Re: *Smoke Tree Resort*

Smoke Tree Resort Neighborhood Meeting Amended Minutes

Rezone: Smoke Tree Resort – Special Use Permit-Major Amendment Application - Proposes to take down the existing structures and construct a new 122-room, three-story resort hotel, including resort related uses, such as a restaurant, event/meeting space, pool, and market.

Location: Smoke Tree Resort, 7101 E. Lincoln Drive, Paradise Valley, Arizona

I have the map highlighted below to show the ownerships.

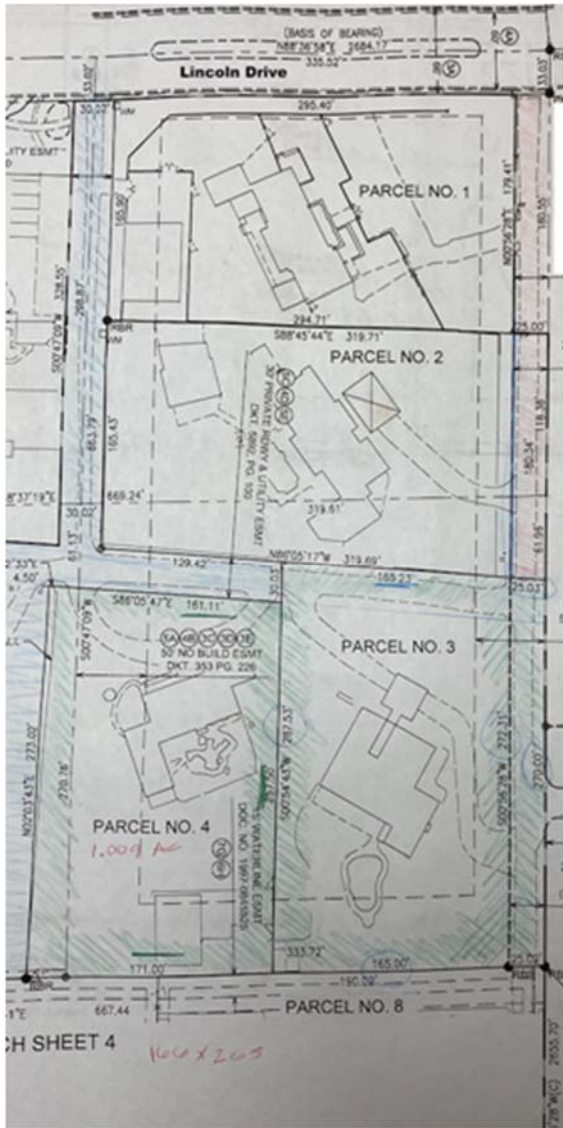
Thanks Paul for your call and help with these serious encroachments on all the private properties here on Quail Run.

Red the areas that were Quick Claim deeded to the Town as private access and has never been changed.

Green Owned by Livi

Blue Owned by Cody at the Dog Kennel

We/Ruttle's own the property directly along south lines of the Green lots.

Staff discussed your questions this morning and better understand the issue.
Your concerns will be noted in the upcoming August 18th Planning Commission meeting packet on the Smoke Tree Resort.
There will likely need to be a meeting with Smoke Tree, the Town, and your family to discuss potential solutions.
